UNITED STATES
NUCLEAR REGULATORY COMMISSION
REGION IV
1600 EAST LAMAR BLVD
ARLINGTON, TEXAS 76011-4511

**SUBJECT: SAN ONOFRE NUCLEAR GENERATING STATION – NRC CONFIRMATORY
ACTION LETTER RESPONSE INSPECTION 05000361/2012009 AND
05000362/2012009**

IR 05000361/2012009; 05000362/2012009; 12/03/2012 – 06/07/2013; San Onofre Nuclear Generating Station; Confirmatory Action Letter Response Inspection.

Figure 4: U-Bend Gap Velocities

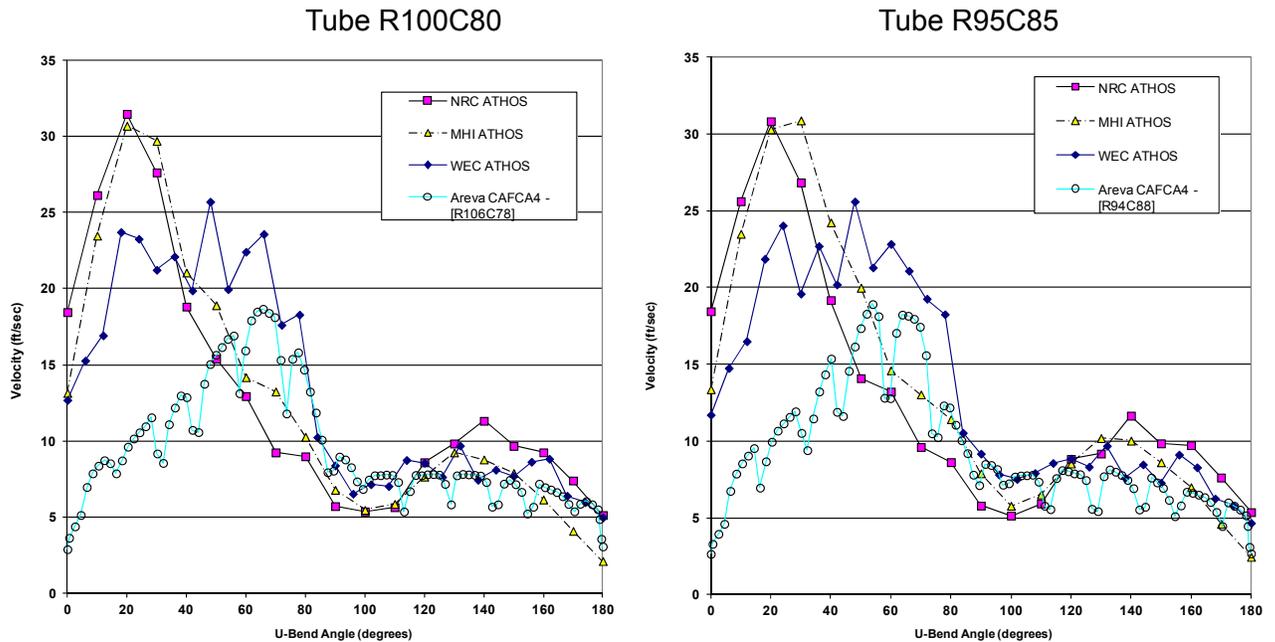
The NRC and Mitsubishi results show the higher peak void fractions, which also peak at a lower location along the U-bend as compared to the Westinghouse and AREVA results. At higher angles along the U-bend, the void fraction predicted by each code tends to merge, and the remainder along the cold side tends to show very similar trends. As expected, comparisons of fluid density show similar trends as the void fraction. Dry saturated steam at about 850 psia has a density of about $2.0 \text{ lb}_m/\text{ft}^3$, and the NRC, Mitsubishi, and Westinghouse results predict that there are significant areas in the U-bend, in the affected region, where velocities are high and steam is nearly dry. Peak velocities and void fraction support the tube-to-tube wear patterns found in the Unit 3 steam generators. The inspectors concluded that the ATHOS code models are adequate to predict the approximate location and magnitude of the high void fraction and velocity, which are the key contributors to tube-to-tube wear found in the U-bend region.

Fig. 1 Critical velocity for onset of FEI as a function of void fraction.

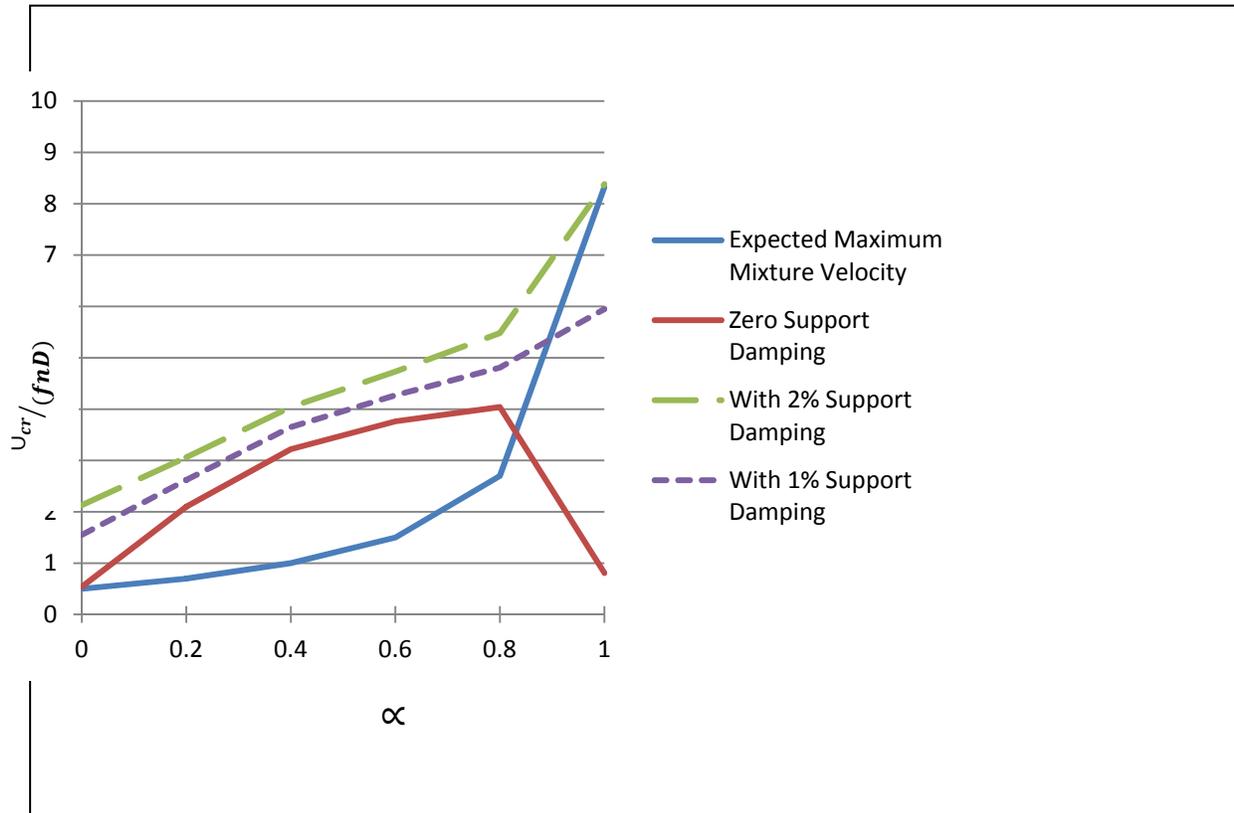
The calculated dimensionless critical velocity for onset of FEI is plotted in Fig. 1 as a function of void fraction, with or without support damping. In this figure the expected two phase mixture velocity through the steam generator (RSG) tube bundle is also plotted as a function of α for an assumed two phase mass flow rate of $65 lbm / ft^2 / sec$ or $315 kg / m^2 / sec$ and natural frequency of $34 sec^{-1}$. It is noted that for void fractions less than 0.8 in the U-bend region of the bundle (for cross flow), the critical velocity for onset of instability is higher than the mixture velocity. As such probability of onset of FEI will be low. However, for void fractions greater than 0.8, the mixture velocity can be substantially higher than the critical velocity, indicating a strong possibility of occurrence of FEI. In RSGs for Units 2 and 3, there is a significant area in the upper U-bend region where calculated void fractions exceed 0.8. When support damping of 1% and 2% is included, the predicted dimensionless critical velocity for onset of FEI increases for all values of α . However, the increase is substantial for high void fractions (greater than 0.8) because now the support damping dominates viscous and two phase damping. With support damping of 1%, the two phase mixture velocity can

exceed the critical velocity for onset of FEI when the void fraction approaches unity. (Although this is not the case for the results plotted in Fig. 1 when support damping of 2% is included in the calculations.) Thus to reduce the propensity of FEI it is essential that very high void fraction regions ($\alpha \approx 1$) in the upper U-bend region of RSGs should be avoided. Figure 1 can be used to determine for individual tubes or clusters of tubes the potential for FEI in Units 2 and 3 RSGs. It should also be noted that lack of contact forces and damping due to anti-vibration bars may be the dominant reason for existence of FEI and severe tube damage in Unit 3 RSGs. As a result of FEI, initially out-of-plane vibrations are expected to occur in the lift direction normal to plane of the tubes. However, this instability in the absence of restraining force from anti-vibration bars can excite in-plane vibration that can be the cause of tube to tube damage.
